Groundwater Application Review Summary Form

Application # G- <u>19362</u>
GW Reviewer _Travis Brown/Stacey Garrison Date Review Completed: _8/13/2025_
Summary of GW Availability and Injury Review:
☐ Groundwater for the proposed use is either over appropriated, will not likely be available in the amounts requested without injury to prior water rights, OR will not likely be available within the capacity of the groundwater resource per Section B of the attached review form.
Summary of Potential for Substantial Interference Review:
\square There is the potential for substantial interference per Section C of the attached review form.
Summary of Well Construction Assessment:
\Box The well does not appear to meet current well construction standards per Section D of the attached review form. Route through Well Construction and Compliance Section.
This is only a summary. Documentation is attached and should be read thoroughly to understand the basis for determinations and for conditions that may be necessary for a permit (if one is issued).

PUBLIC INTEREST REVIEW FOR GROUNDWATER APPLICATIONS TO: Water Rights Section Date 8/13/2025 FROM: Groundwater Section Travis Brown/Stacey Garrison Rev

Hydrograph

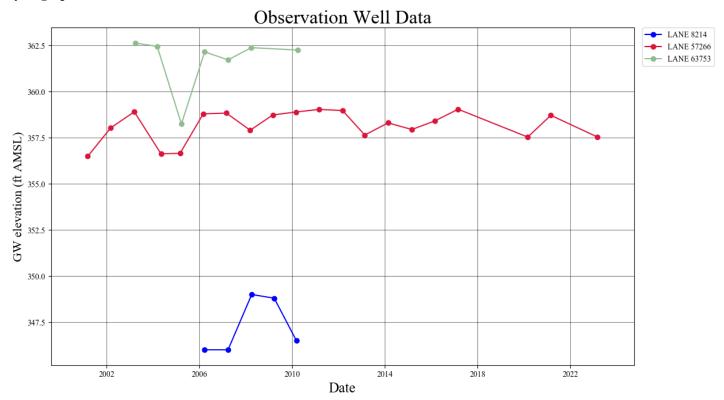
Nearby water levels are not excessively declined or declining (see attached Hydrograph). The requested groundwater source is not over-appropriated.

Well Statistics - T16S/R4W-34 and surrounding sections

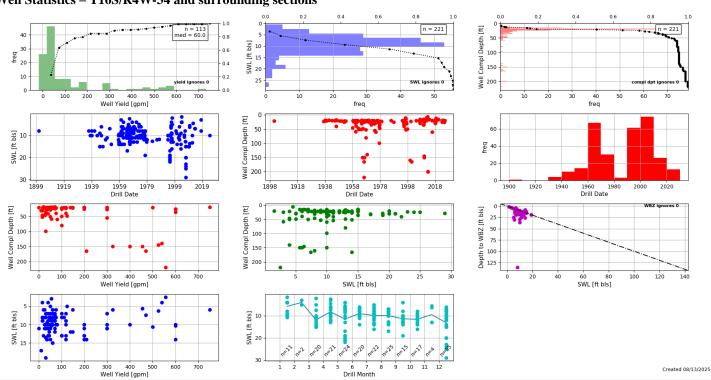
The applicant has requested a maximum rate of 0.75 cfs (~337 gpm); this is 45% of the maximum yield (750 gpm) and 562% of the median (60 gpm) for pumping-type pump tests in the area. The LANE 80103 alteration log for the POA shows an airtype pump test with a yield of 400 gpm; air tests are not considered reliable for determining yield. In addition, the 400 gpm yield record does not include drawdown, only lasted 1.5 hours, and was not accompanied by static water level measurements. A query for pump-type pumping tests was completed for the area. Nearby wells developed similarly to the POA report yields greater than the requested rate (LANE 11705, LANE 11707). Other alluvial wells in T16S/R4W-34 and the surrounding sections have reported higher yields that would be sufficient to supply the requested rate (see attached Well Statistics). Therefore, the proposed use is likely within the capacity of the groundwater resource.

Basis for aquifer confinement evaluation: The POA has a likely confining unit of clay and cemented gravel 2-22 ft bls; the reported static water level (5 ft bls) was above the noted water-bearing zone (24-79 ft bls). Other wells in the area indicate SWLs above reported water-bearing zones, indicating confined conditions (see attached Well Statistics). Therefore, the target aquifer appears to be at least weakly confined.

Theis Drawdown and Recovery at r = 1550 ft From Pumping Well

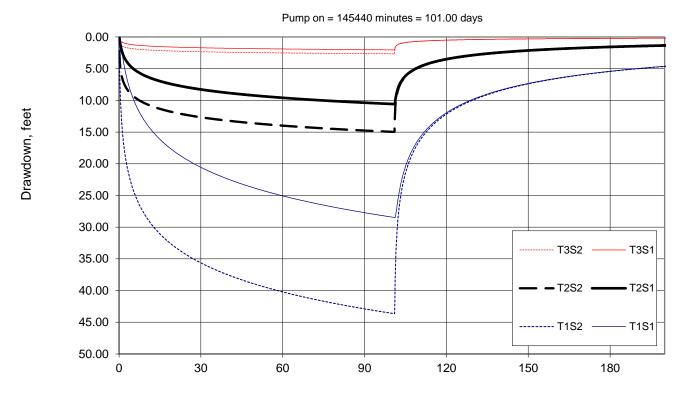
The nearest neighboring alluvial well (presumed to be LANE 8316) is on Tax Lot 1202, ~1,550 ft east of the proposed POA. Well-to-well interference at this distance was analyzed using the Theis (1935) solution for drawdown in a confined aquifer (see attached Well-to-Well Interference Analysis). Results of the analysis indicate that interference from the proposed use is unlikely to exceed 25 ft of drawdown at the location of Tax Lot 1202.

Radial distance, r = 1,550 ft [approximate distance from POA to TL 1202]

Pumping rate, Q = 0.75 cfs [maximum requested rate]

Pumping time, $t_{pump} = 101$ days [approximate time to exhaust fully duty at maximum rate]

Transmissivity, T: T1 = $780 \text{ ft}^2/\text{day} \mid \text{T2} = 2,700 \text{ ft}^2/\text{day} \mid \text{T3} = 19,000 \text{ ft}^2/\text{day}$ [Pumping Test Reports]

Storativity, S: $S1 = 0.001 \mid S2 = 0.0001$ [Conlon et al., 2005]

To protect senior users and the groundwater resource, the conditions in B1(d)(i) and B2(c) are recommended for any permit issued pursuant to this application. The reference level for the proposed POA is listed in Table A3.
